CUP14-00008 / Hackamore, LLC

Conditional use permit for a 16-unit residential development on 1.21 acres located at 8743 W. Hackamore Drive in a C-3D/DA (Service Commercial with Design Review and Development Agreement) zone.

Planning Division Report

File Number CUP14-00008
Applicant Hackamore, LLC
Property Address 8743 W. Hackamore Drive

**PROPOSED SITE PLAN
LANDMARK APARTMENTS**

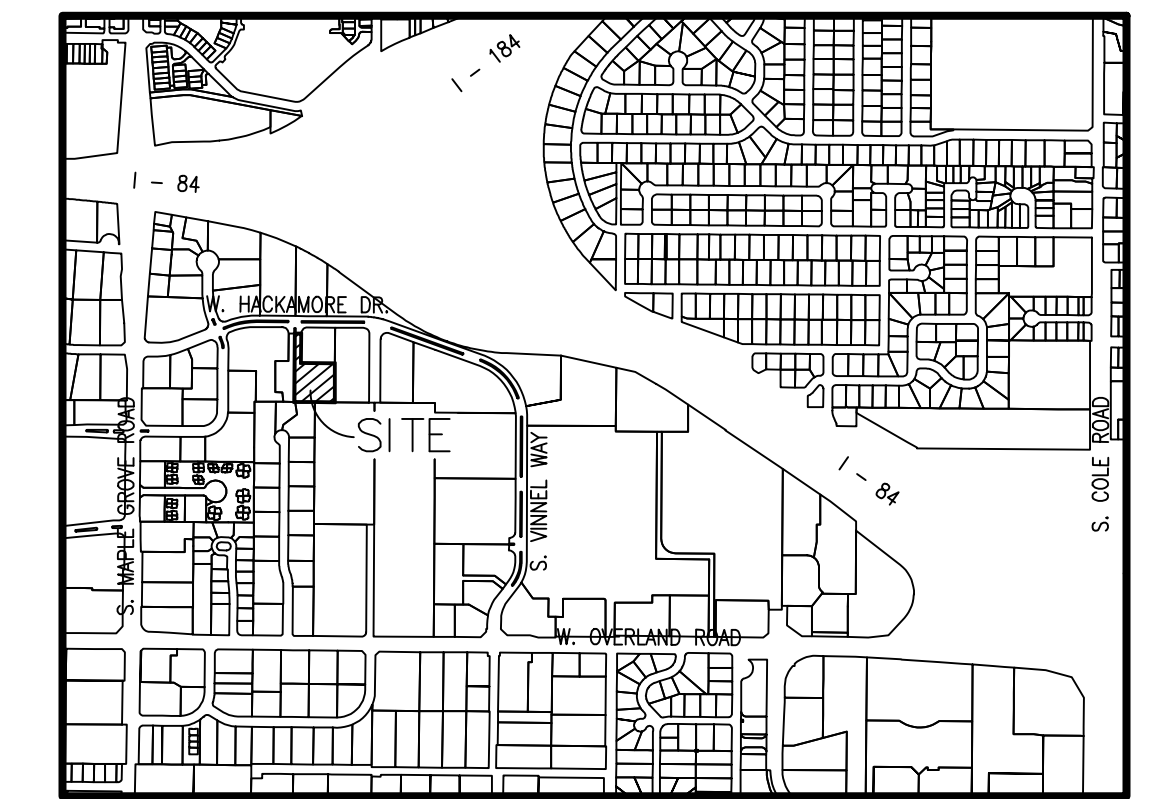
Public Works Solid Waste Division's memo dated February 28, 2014 notes the location of the dumpster is not acceptable as a garbage truck can't turnaround inside the development. A revised site plan shows the dumpster along the service drive and allows enough room for a turnaround. Dumpsters are not normally allowed in front of a project's buildings. In this case, the dumpster will be located along a service drive and will not be visible from a public street.

1. The proposed enclosure does not meet the City of Boise requirements.
2. If a single trash dumpster is to be used the enclosure must be 12'X12', with gates opening 120 degrees
3. In addition the access requirements have not been met; specifically there is no area for the truck to turn around.
4. Consider adding a man door to the enclosure for ease of access and reduced conflict with parked cars.
5. Review size requirements for the enclosure based on the number of containers desired.

4. Comply with the requirements of the Boise City Public Works Solid Waste Division as specified in the attached memo dated **February 28, 2014**.
5. Comply with the requirements of the Boise City Public Works Department (BCPW) for drainage, sewers, Solid Waste/Ground Water Manager, and street lights as specified in the attached comments dated **February 28, 2014**. Please contact BCPW at 384-3900. All items required by BCPW shall be included on the plans/specifications that are submitted for a Building Permit. Please note that any changes or modifications by the owner to the approved Storm Water Plan must be resubmitted to BCPW for approval.

PROPOSED LANDSCAPE PLAN
LANDMARK APARTMENTS
LOT 13, BLOCK 2, CENTURY LANDMARK CENTER NO. 2
SW 1/4 SECTION 13, T.3N., R.1E., B.M.
CITY OF BOISE, ADA COUNTY, IDAHO

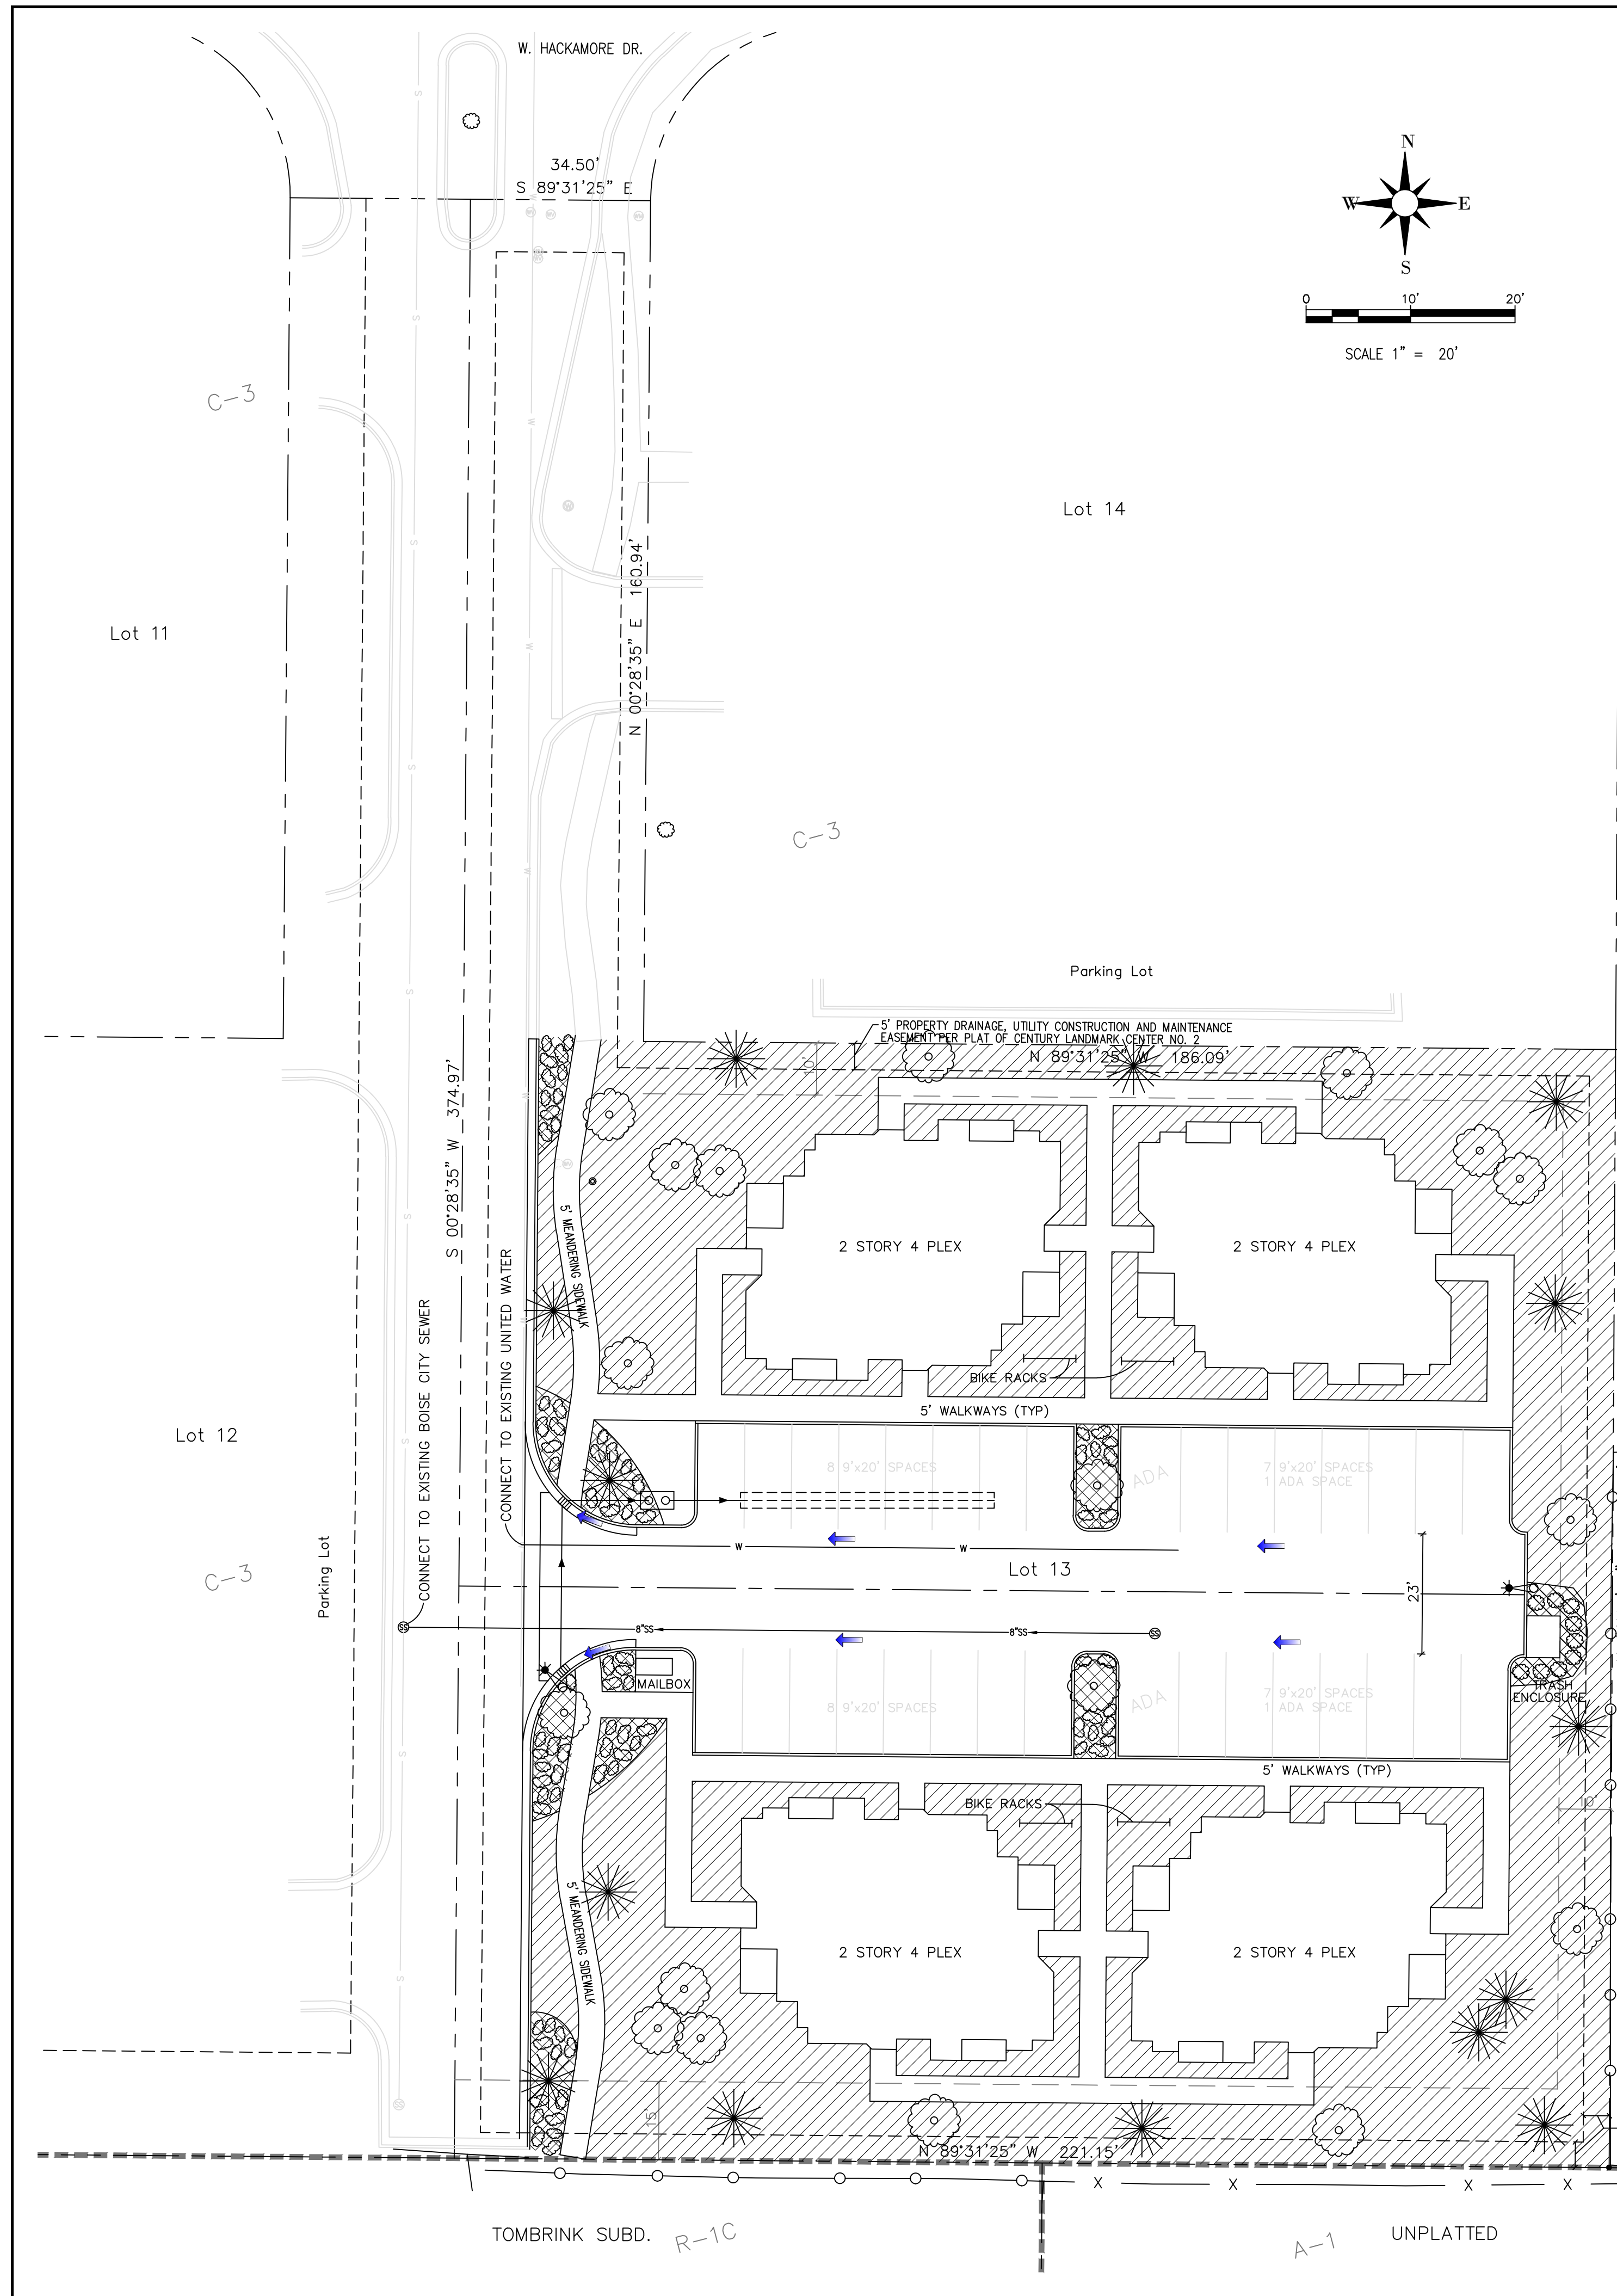
The project meets all setback and parking requirements. The project provides at least 10% of the lot area outside of setbacks as open space. The landscape plan will have to be modified prior to approval by Design Review. There are scattered trees and shrubs around the site but no foundation plantings between sidewalks and the face of the building.

2. The applicant shall construct a pedestrian pathway to the south near the eastern edge of the property boundary.
3. The applicant shall work with Design Review to provide additional foundation plantings and perimeter landscaping.
